**RE: Major Site Plan Review – Multi-family Residential Adaptive Reuse
Map 6414Z, Lot 1
103 North State Street
City Of Concord, Merrimack County, New Hampshire**

**RE: Staff Report Response Letter
Multifamily Conversion – Major Site Plan (2026-028)
Associated Enterprises, Inc.
Map 6414Z, Lot 1
145-171 Chase Avenue
City of Concord, Merrimack County, New Hampshire
Application #: 2026-028**

The following is an itemized response to the comments contained within the City of Concord Staff Report dated April 15, 2026. For the sake of brevity, any comments that are statements of fact or have been previously addressed are not included in the response below:

DRAWING:
C-4

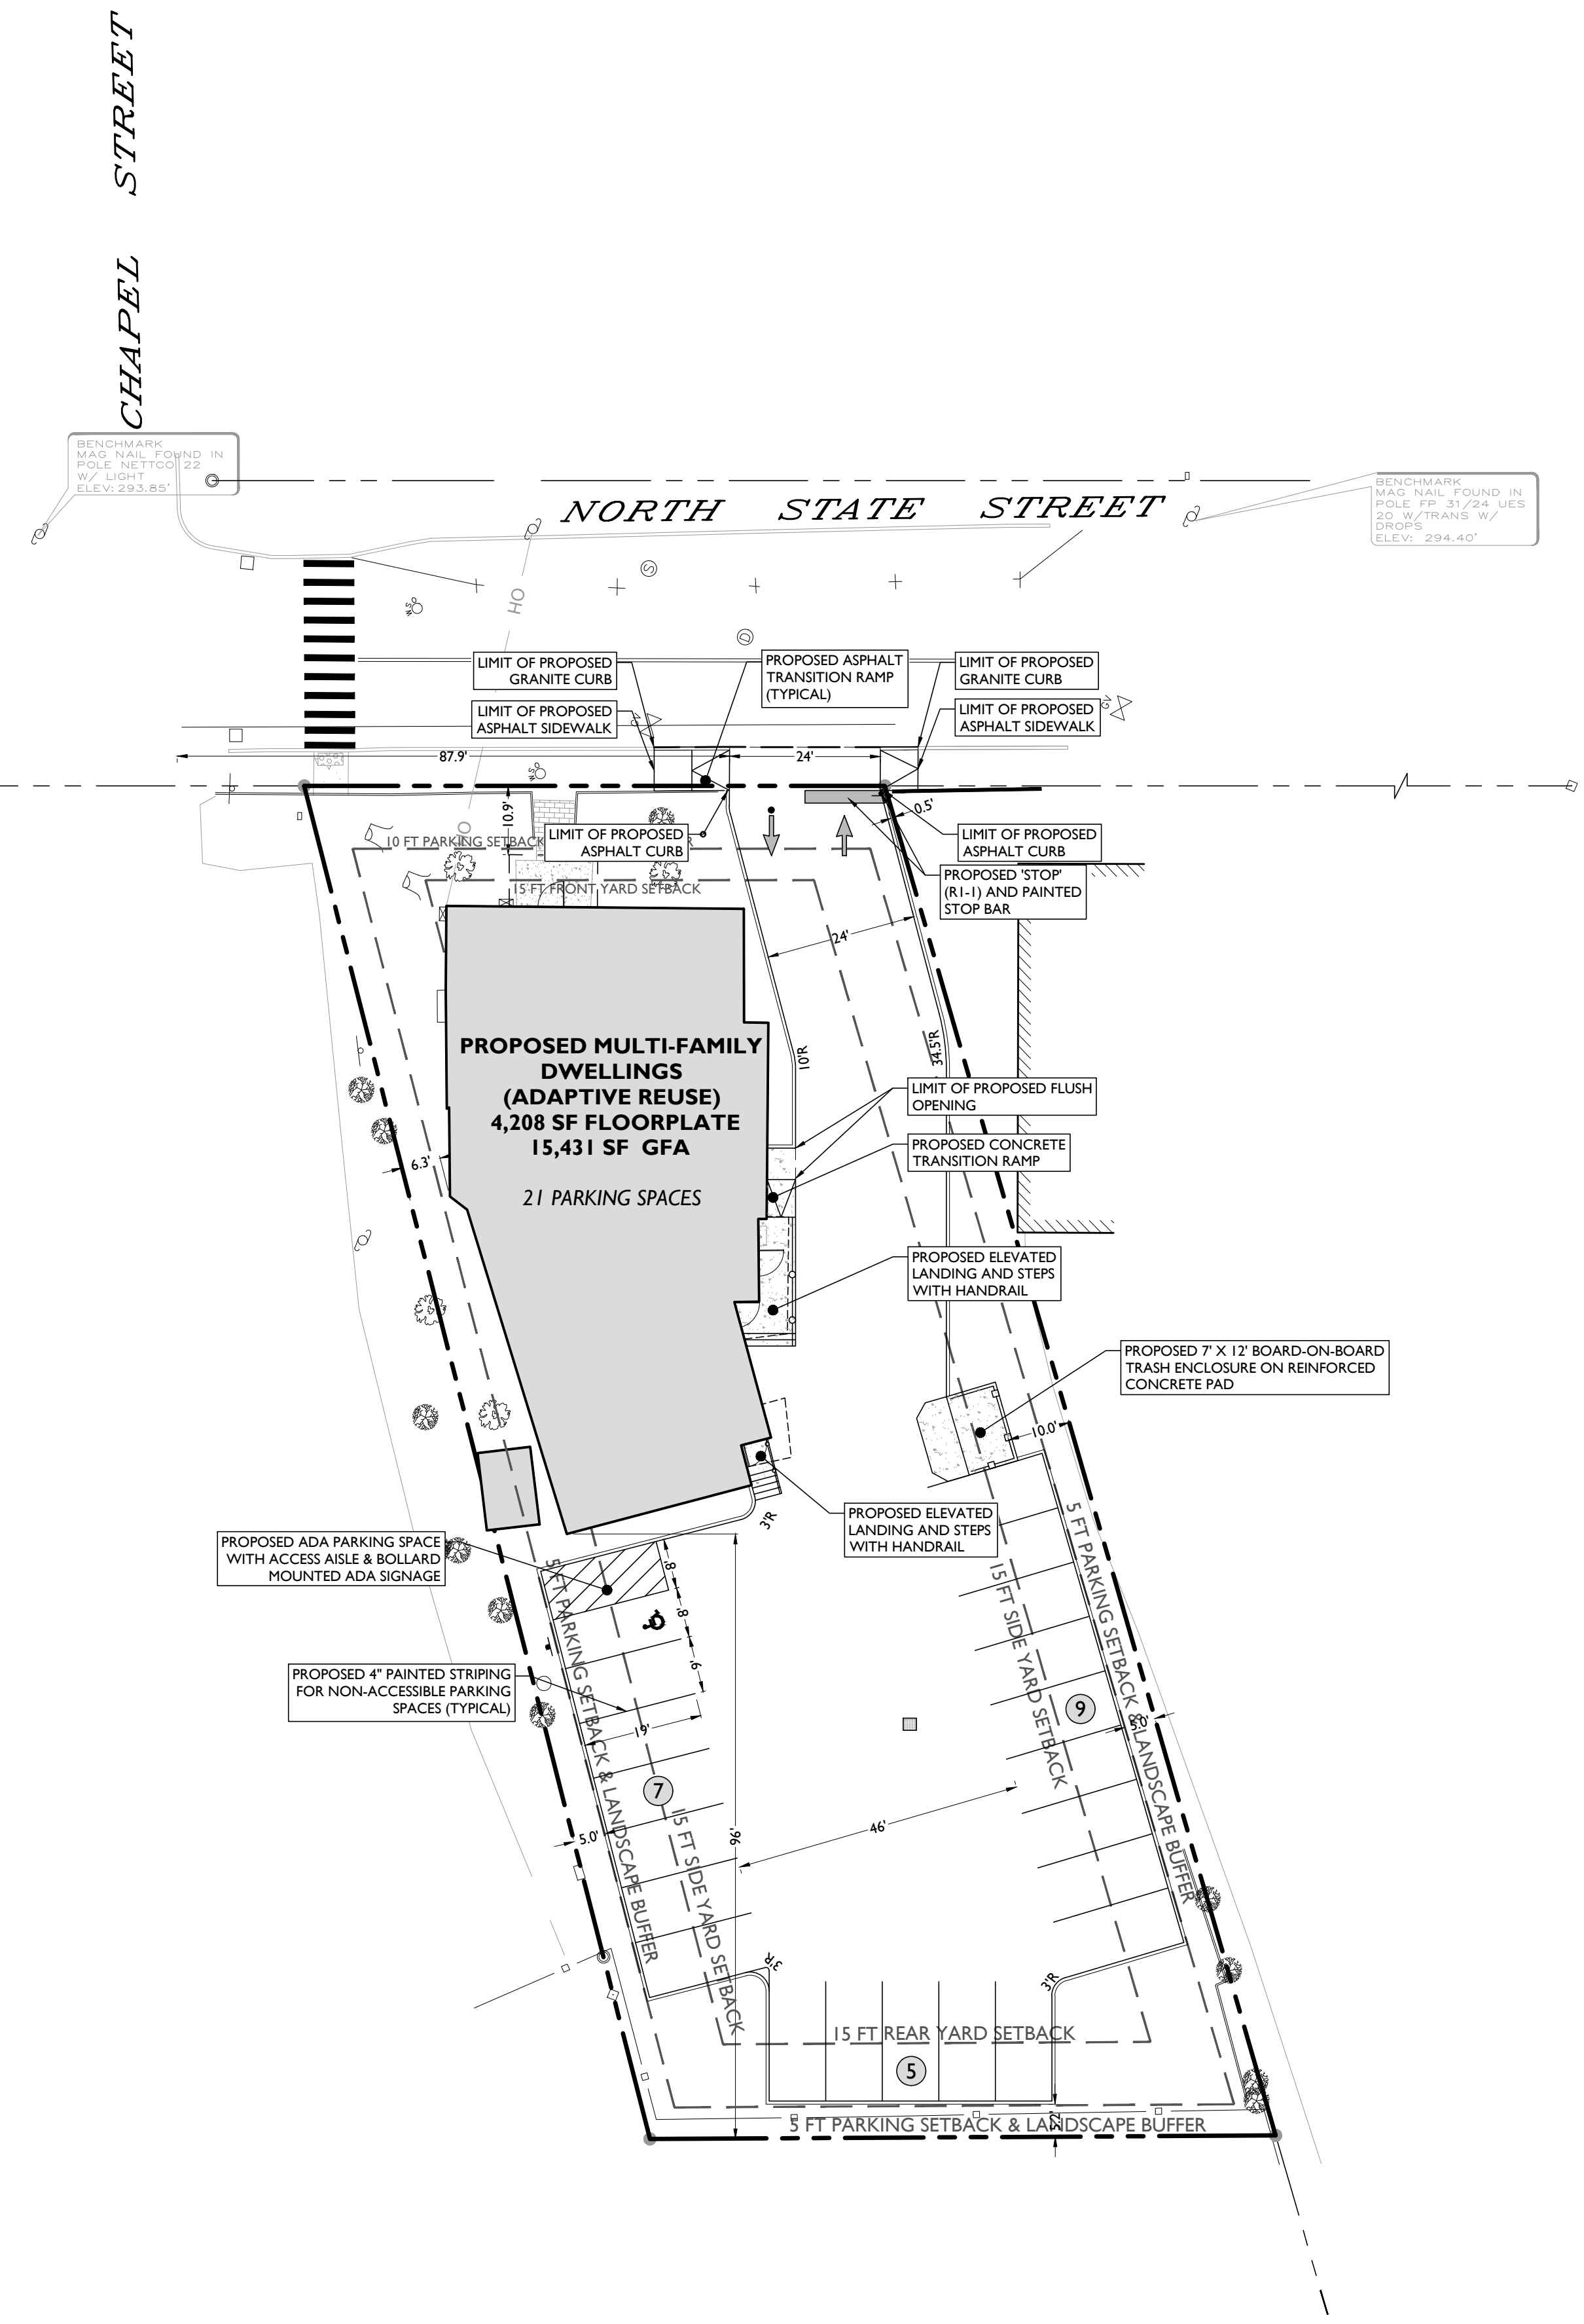
- 3.14 Section 15.04(1) Property Lines requires on the site plan the property lines of the parcel to be developed with bearings and dimensions. Specifically, the bearings and dimensions of the parcel's property lines shall be added to the site plan.

- 3.15 Section 15.04(4) Proposed Use requires each site plan shall clearly identify each existing and proposed use planned for the site. Specifically, a note shall be added to the site plan clearly identifying the existing and proposed use.

- 3.17 Section 15.04(23)(g) requires on the site plan a tabulation of the total number of dwelling units, and total number of dwelling units by type and number of bedrooms. Specifically, a note shall be added to the site plan for the total number of dwelling units and the total number of dwelling units by type and bedrooms.

- 3.18 Section 15.04(23)(L) requires on the site plan a tabulation of required parking and loading areas, including handicapped and compact spaces. Specifically, the tabulation of required handicap accessible spaces shall be added to the parking tabulations on the site plan.

3.24 Section 18.06 Handicap Accessible Spaces requires parking spaces for vans carrying handicapped individuals shall contain a rectangular area of at least 19-feet in length and 11-feet in width, together with an access aisle of 5-feet in width immediately adjacent to the parking space. Whereas only 1 accessible space is provided and required it shall be van accessible. Specifically, the proposed dimensions of the accessible space and adjacent access aisle shall be revised so that the space is 11-feet wide and the access aisle is 5-feet in width to conform with Section 18.06 of the Site Plan Regulations and City of Concord Construction Detail M-4 Parking Space Layout.

3.27 Section 18.21 Snow Storage requires provisions shall be made for snow storage in the design of all parking areas and snow storage areas shall be shown on the site plan. Snow storage areas shall be functional and designed to avoid damage to landscaping, to not impede site drainage, to not block pedestrian ways, or hinder vehicular access or block site lines at intersections, either on or off site. Specifically, the site plan shall show and note any and all provisions for snow storage of the site.

- 3.37 *In addition to remaining on the cover sheet of the civil plan set, the Planning Board approval block also needs to be added to Sheet C-4 Site Plan.*

- c. *Please show a striped, accessible path of travel from the handicap unloading area to the front entrance, pursuant to 2010 ADA Standards requirements and CSPR 21.04, and as referenced in ADA Note (5) on Sheet C-5.*

- h. *Show driveway flares where the proposed drive connects to N. State Street, as required in Detail D-5 on Sheet C-13, and pursuant to CSPR 18.10.*

The requested bearings and dimensions have been provided on the Existing Conditions Sheet (Sheet C-2).

The Submission materials have been updated to reflect the existing and proposed use for the site on the Site Plan Sheet (Sheet C-4).

The Submission materials have been updated to include a tabulation of total number of dwelling units, total number of dwelling units by type, and number of bedrooms on the Site Plan Sheet (Sheet C-4).

The off-street parking requirements table has been updated to include accessible parking requirements and the proposed counts of accessible parking spaces. Refer to the Site Plans Sheet (Sheet C-4).

The Site Plan has been updated to reflect the dimensions of the for a van accessible parking space with a 19-feet in length and 11-feet in width parking space and 19-feet in length and 5-feet in width access aisle. Refer to the Site Plan Sheet (Sheet C-4).

The submission documents have been updated to reflect the snow storage locations and size information on Site Plan Sheet (Sheet C-4).

The Site Plan Sheet has been updated to include the Planning Board approval block. Refer to the Site Plan Sheet (Sheet C-4).

The Site Plan has been updated to show a proposed 4-foot in width striped access path from the ADA access aisle to the front of the property. Refer to the Site Plan Sheet (Sheet C-4).

The Site Plans has been updated to reflect the driveway as shown in detail D-5. Refer to the Site Plan Sheet (Sheet C-4).

STABILIZED CONSTRUCTION ACCESS DETAIL

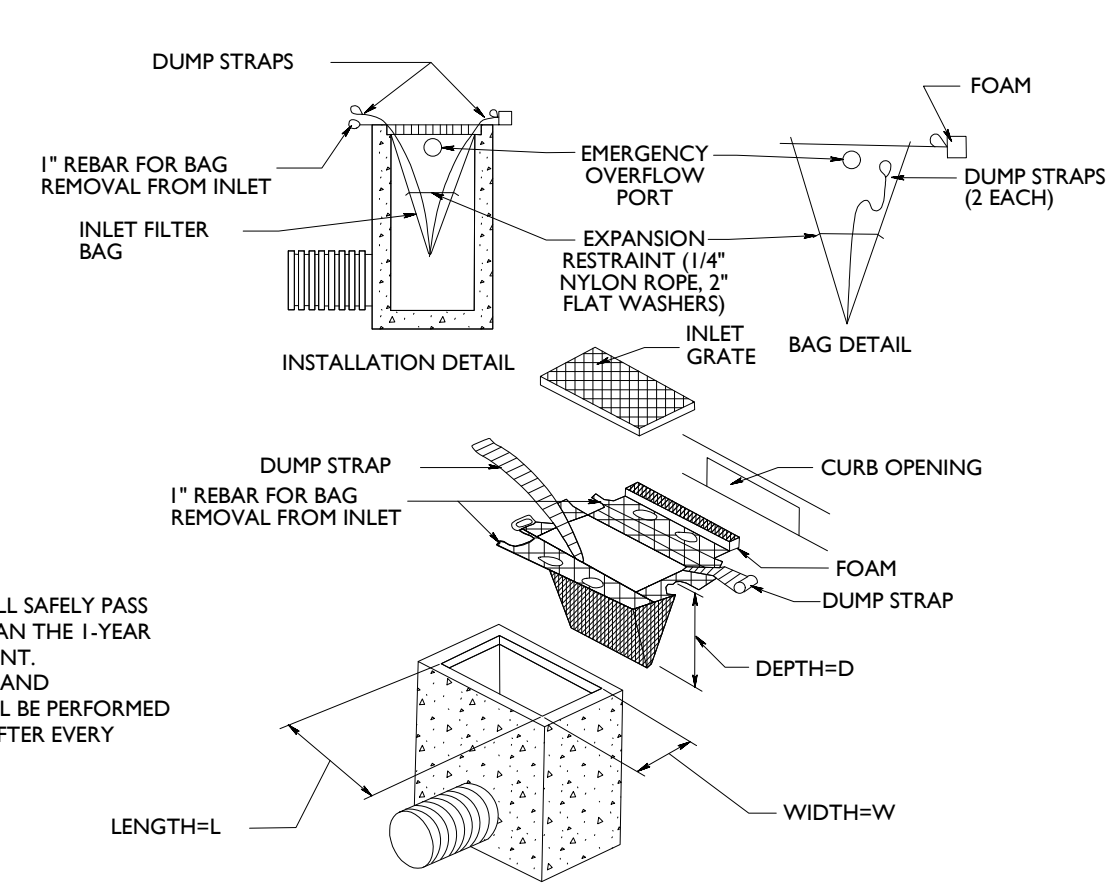
- a. Replace the Stabilized Construction Access Detail with CCSD Detail E-1.

The Soil Erosion and Sediment Control Details have been updated to include Detail E-1. Refer to the Soil Erosion and Sediment Control Details Sheet (C-9).
